From: Mike Hager <mhager@AHBL.com>
Sent: Wednesday, January 30, 2019 10:59 AM
To: Eatch Beck - Capital Projects <BeckE@ckschools.org>
Cc: Nick Rheaume <NRheaume@AHBL.com>
Subject: RE: 20190122 - CKHSMS CDC 130 - Soule RD connection (003).pdf

From: Eatch Beck - Capital Projects [mailto:BeckE@ckschools.org]
Sent: Wednesday, January 30, 2019 10:27 AM
To: Mike Hager
Cc: Eatch Beck - Capital Projects; Nick Rheaume
Subject: 20190122 - CKHSMS CDC 130 - Soule RD connection (003).pdf
Importance: High

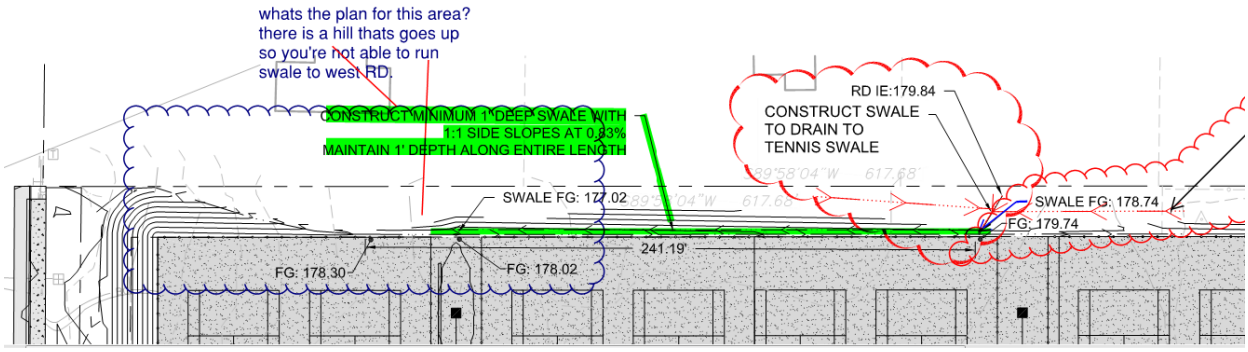
At the west end of the tennis courts the elevation goes up it appears that this solution might pond the water further down the tennis courts.

They will need to regrade along the entire length of the tennis courts until it drops down the hill/swale. The exhibit has the note "CONSTRUCT MINIMUM 1' DEEP SWALE WITH 1:1 SIDE SLOPES AT 0.83%. MAINTAIN 1' DEPTH ALONG ENTIRE LENGTH". This note is pointing out the swale that was already a part of the plans, but was never constructed. This swale will need to be constructed in order for the area to drain.
